Design Review Board Meeting
February 5, 2009
Agenda Item: **D1**

Design Review Board Meeting
February 5, 2009
Agenda Item: **E3**

Design Review Board Meeting
February 5, 2009
Agenda Item: **F5**

Subject: 42 Reed Ranch Road; File No. 20816; Site Plan and Architectural Review for Construction of Additions to an Existing Single-Family Dwelling With Variances for Reduced Front and Side Yard Setbacks, Excess Lot Coverage, Excess Wall and Fence Height, and a Floor Area Exception

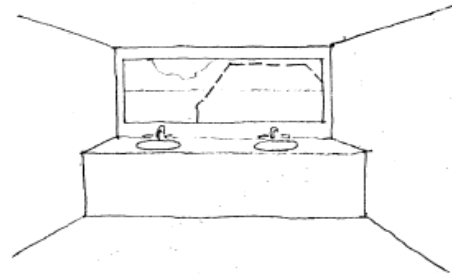
The proposed addition would block a slot view of Blackie's Pasture when viewed from the living room of 41 Reed Ranch Road.

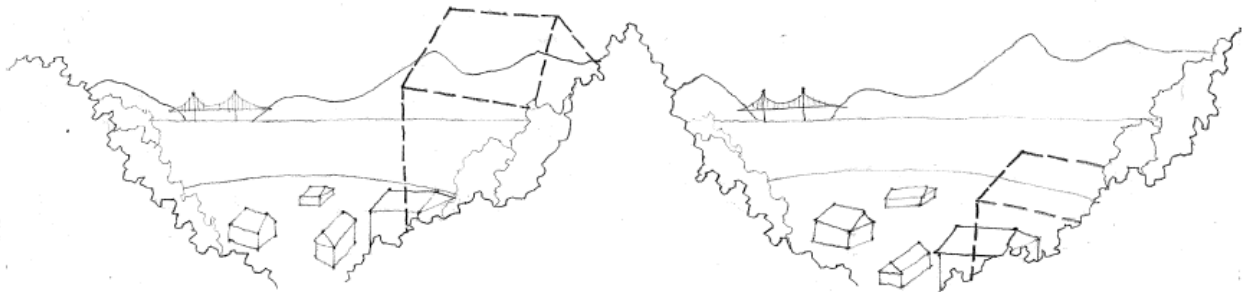
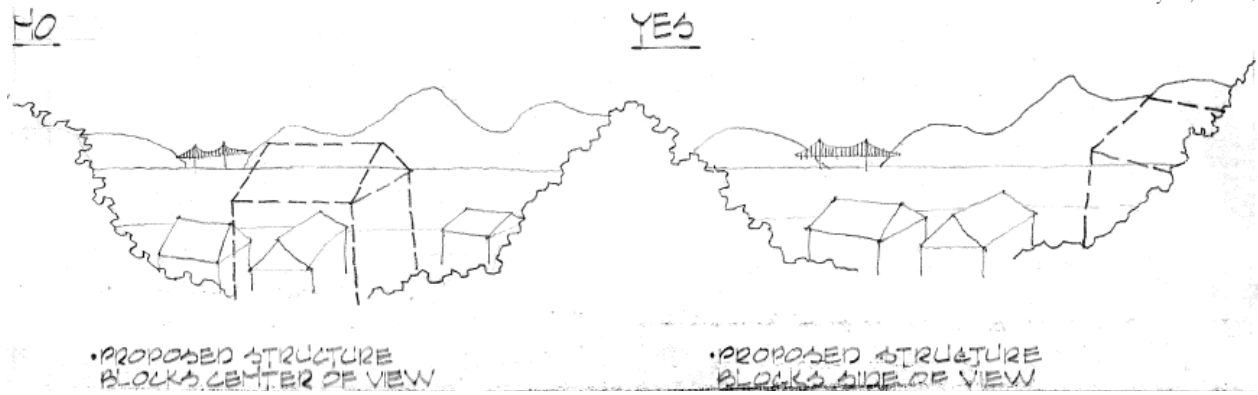
The addition would not affect the horizon line of the viewshed for 41 Reed Ranch Road, but would only minimally affect the foreground of the viewshed.

The proposed addition would not block the center of the viewshed for 41 Reed Ranch Road, but would block a side view in the foreground of the viewshed.
